WKL3 - Replacing Ball Pins on Rear Lid (Workshop Campaign)

Model Line: **Cayenne (9YB)**

Subject: **Replace ball pin on rear lid**

Installation position of ball pins for actuating cylinder

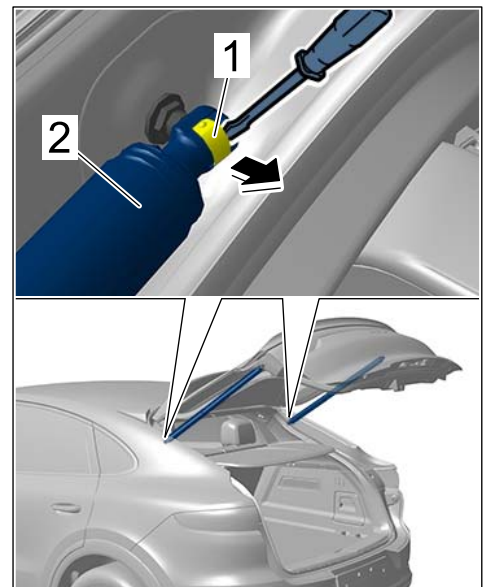
Information: **There is a possibility that the ball pins for securing the actuating cylinders for the rear lid will loosen from the body over the service life of the vehicle due to a manufacturing error.**

The resultant increased notch effect can cause the ball pins to break, resulting in unintentional lowering of the lid.

Remedial Action: Replace ball pins on the rear lid at the left and right.

Loosening actuating cylinder

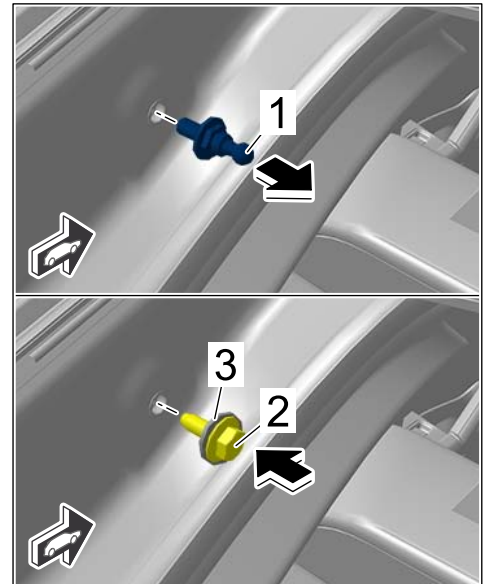
- 1 Loosen actuating cylinder at the ball pin on the body at the left and right.
 - 1.1 Insert a screwdriver between the safety clip ⇒ *Loosening actuating cylinder -1-* and rear lid actuating cylinder ⇒ *Loosening actuating cylinder -2-*.
 - 1.2 Lift the safety clip by levering the screwdriver. The safety clip remains on the rear lid actuating cylinder.
 - 1.3 Pull rear lid actuating cylinder off the ball pins ⇒ *Loosening actuating cylinder -Arrow-*.

*Replacing ball pins**Installing ball pins*

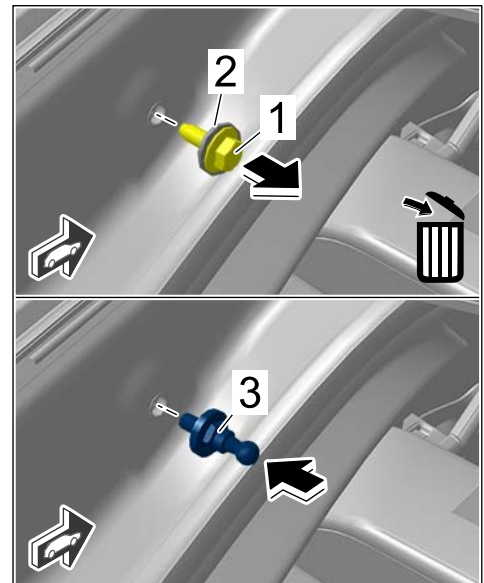
- 2 Replace ball pins on the rear lid at the left and right.
 - 2.1 Unscrew and dispose of ball pin ⇒ *Replacing ball pins -1-*.
 - 2.2 Pre-compress the sealing duct in the body. To do this, tighten the hexagon-head bolt ⇒ *Replacing ball pins -2-* (Part No. P908408) with the washer ⇒ *Replacing ball pins -3-* (Part No. P91257201) at the screw point of the ball pin to the specified tightening torque. Wait 5 minutes before loosening the hexagon-head bolt and pre-compress it again to the specified tightening torque.
Tightening torque 30 Nm (22 ftlb.)

- 2.3 Unscrew hexagon-head bolt with washer and repeat the procedure on the other side of the vehicle.
 - 2.4 Unscrew hexagon-head bolt ⇒ *Installing ball pins -1-* with washer ⇒ *Installing ball pins -2-* and dispose of it ⇒ *Installing ball pins -Arrow-*.

- 2.5 Tighten new ball pins ⇒ *Installing ball pins -3-* to the specified tightening torque.
Tightening torque 25 Nm (19 ftlb.)
